PROJECT NAME: SIte Plan for Fit Sport Life

REA-Rockwall Land, LLC for the approval of a Site Plan for a Golf Driving Range on an 9.942-acre tract of land being portions of a larger 18.131-acre tract of land and a 12.868-acre tract of land identified as Tract 22 & 22-2 of the R. Irvine Survey, Abstract No. 120, City of Rockwall, Rockwall County, Texas, zoned Commercial (C) District, situated within the IH-30 Overlay (IH-30 OV) District,

DEPARTMENT	REVIEWER	DATE OF REVIEW	STATUS OF PROJECT	
PLANNING	Henry Lee	03/22/2024	Needs Review

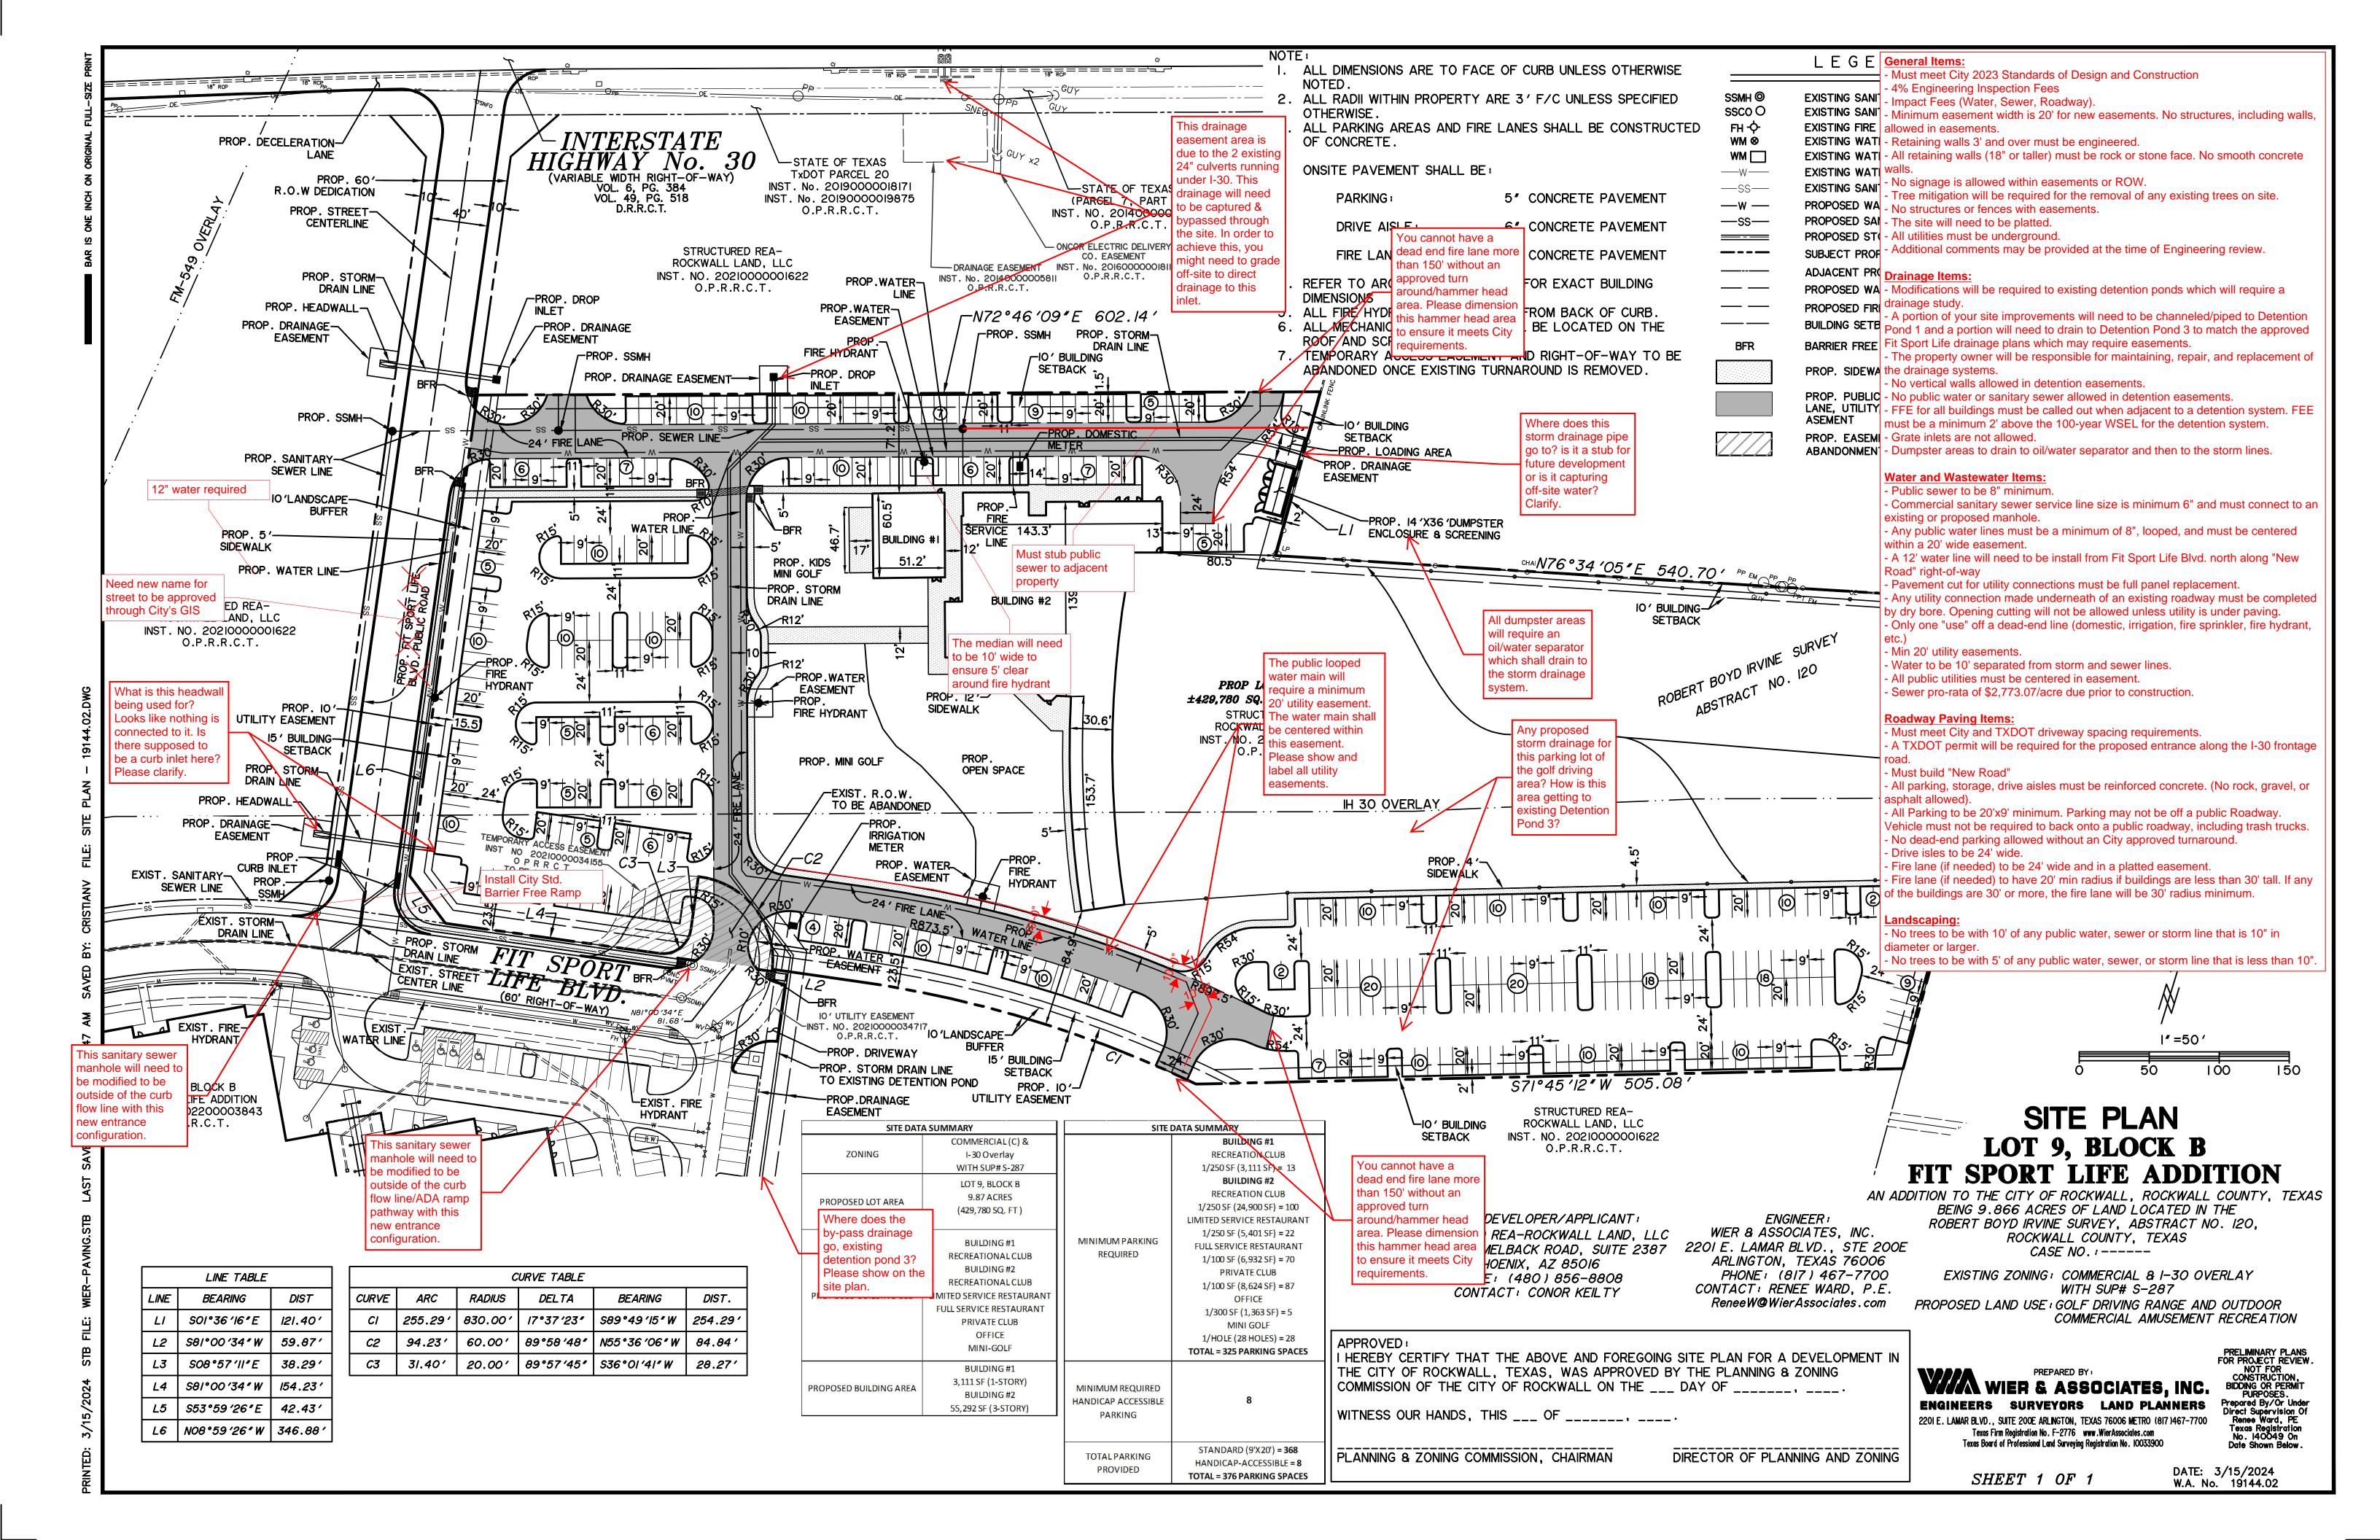
- 2. Need new name for street to be approved through City's GIS
- 3. What is this headwall being used for? Looks like nothing is connected to it. Is there supposed to be a curb inlet here? Please clarify.

- 4. This sanitary sewer manhole will need to be modified to be outside of the curb flow line with this new entrance configuration.
- 5. Install City Std. Barrier Free Ramp

- 6. This sanitary sewer manhole will need to be modified to be outside of the curb flow line/ADA ramp pathway with this new entrance configuration.
- 7. Where does the by-pass drainage go, existing detention pond 3? Please show on the site plan.

- 9. Any proposed storm drainage for this parking lot of the golf driving area? How is this area getting to existing Detention Pond 3?
- 10. The public looped water main will require a minimum 20' utility easement. The water main shall be centered within this easement. Please show and label all utility easements.

- 13. Must stub public sewer to adjacent property
- 14. Where does this storm drainage pipe go to? is it a stub for future development or is it capturing off-site water? Clarify.

L1.03 LANDSCAPE PLAN LOT 9, BLOCK B FIT SPORT LIFE ADDITION

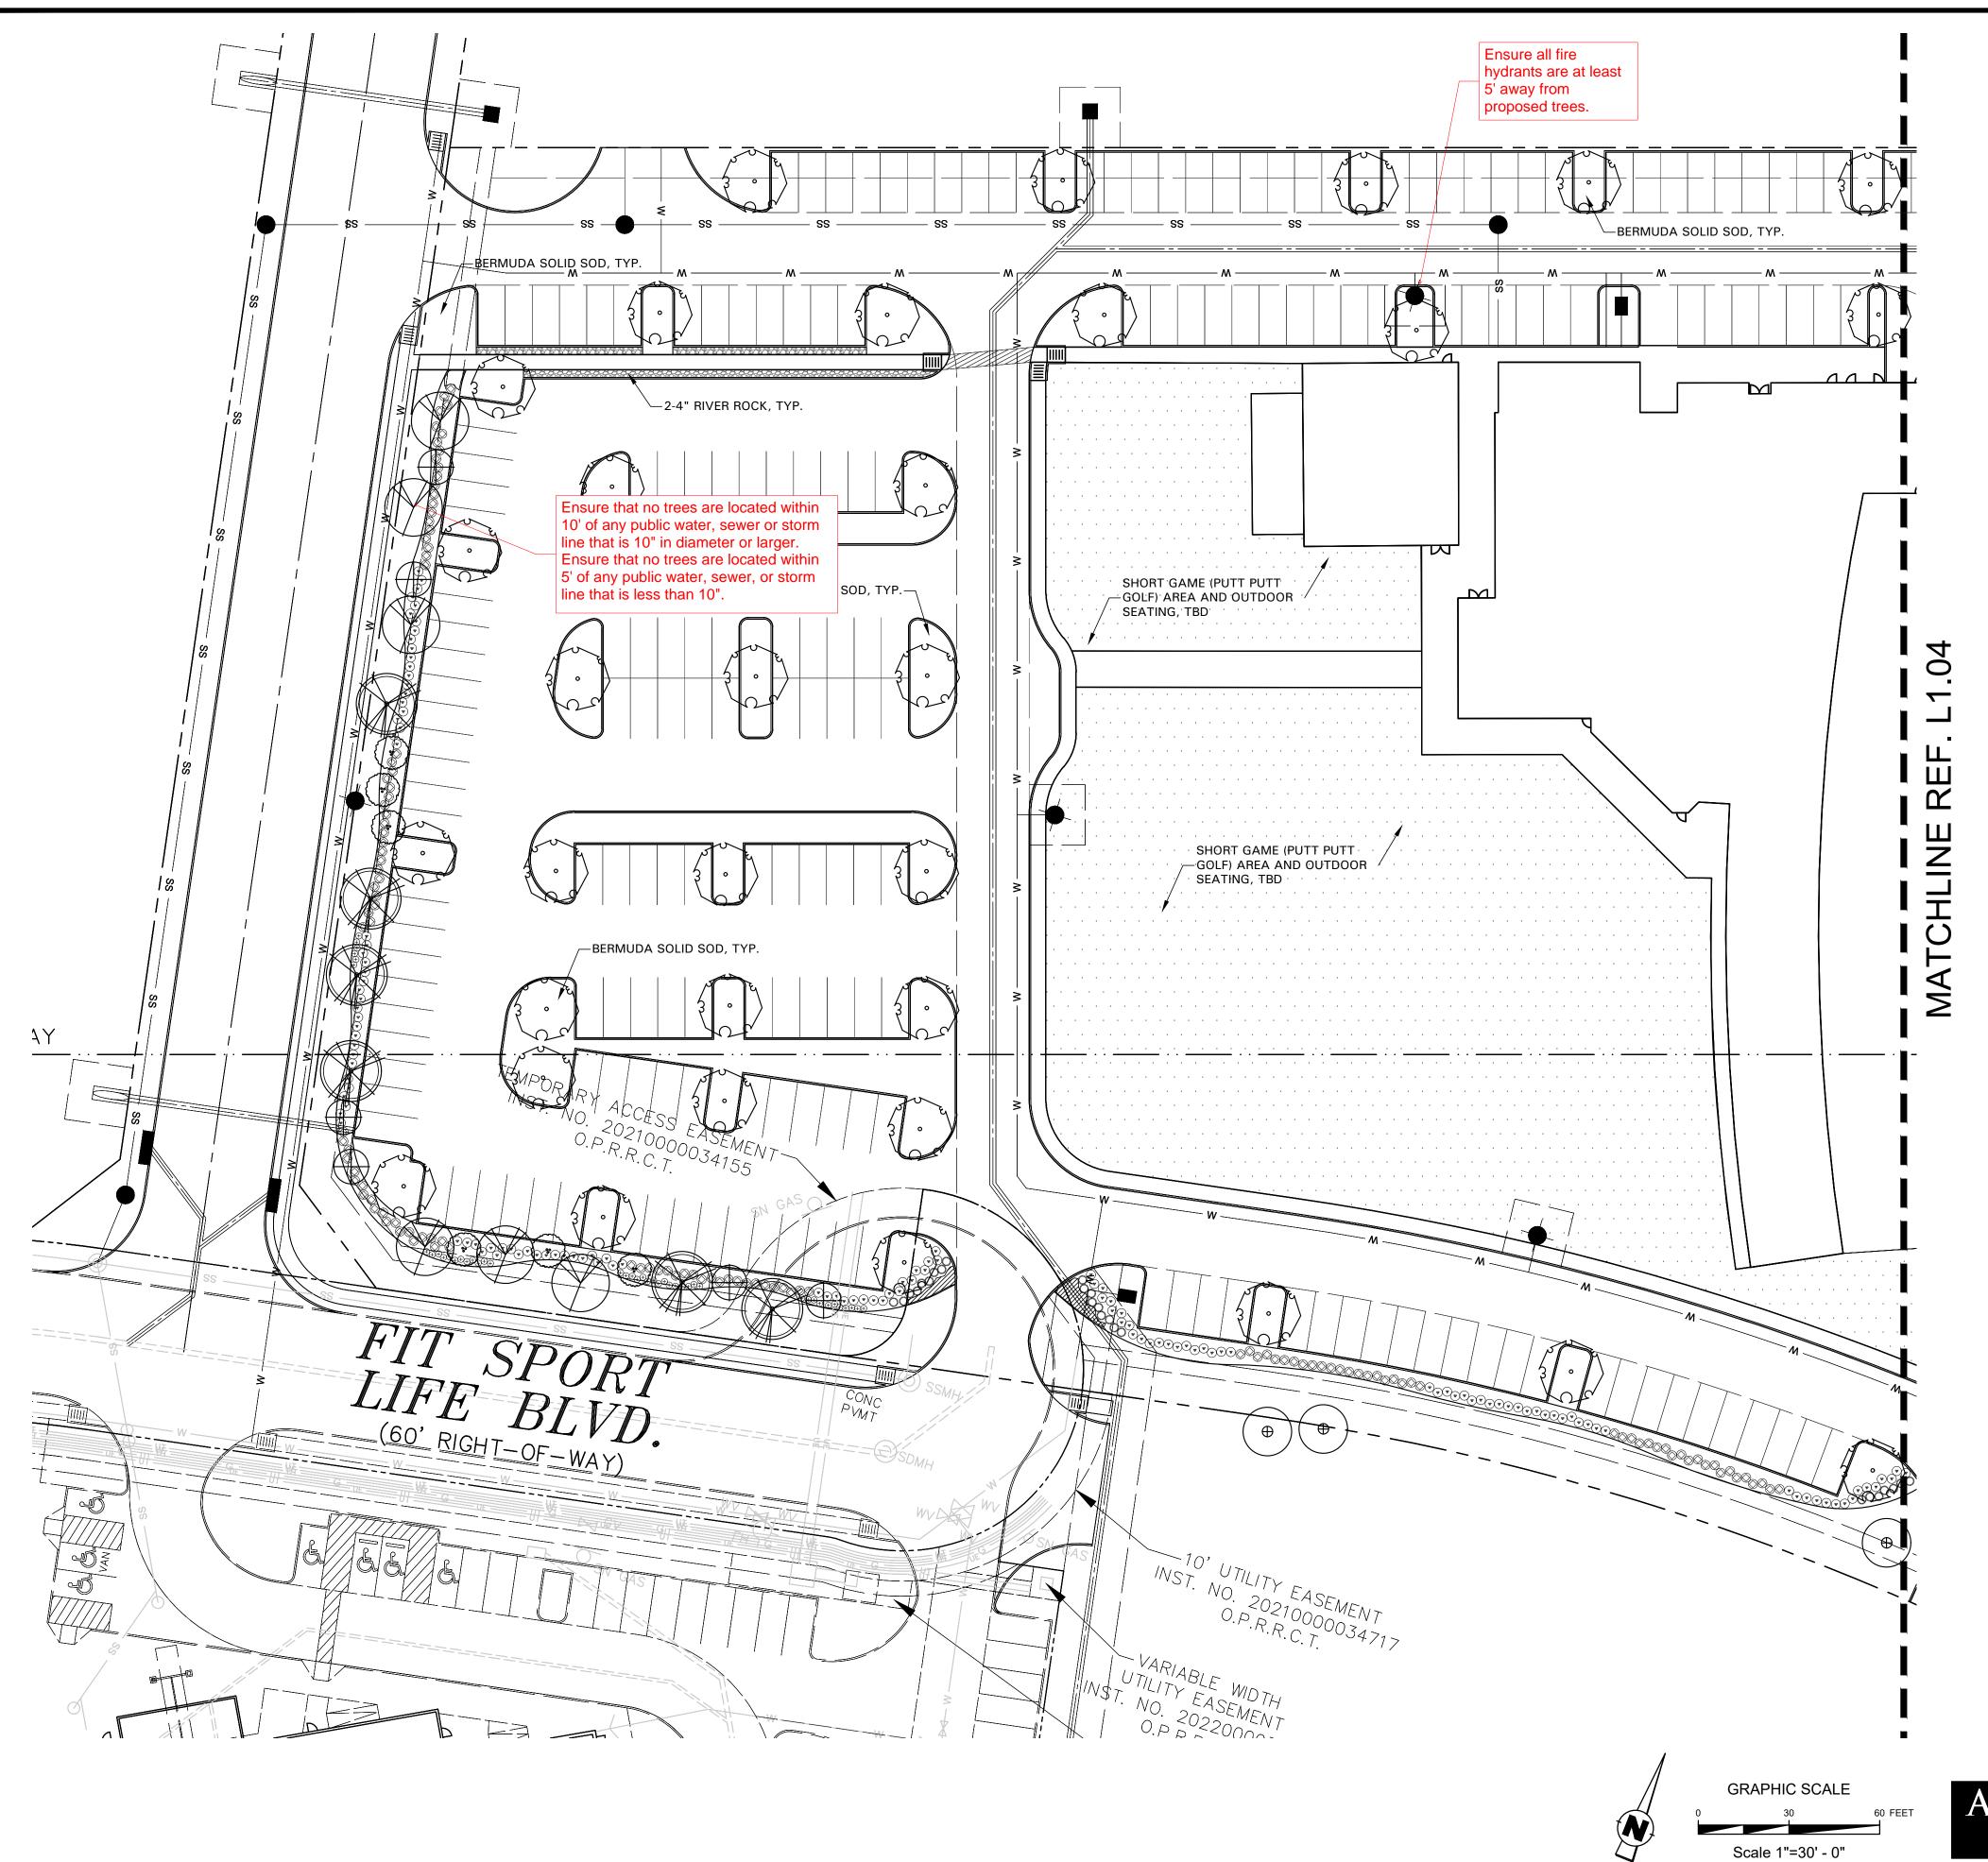
03/18/2024: Please provide a landscape plan with required versus proposed legend and plant variety and size legend.
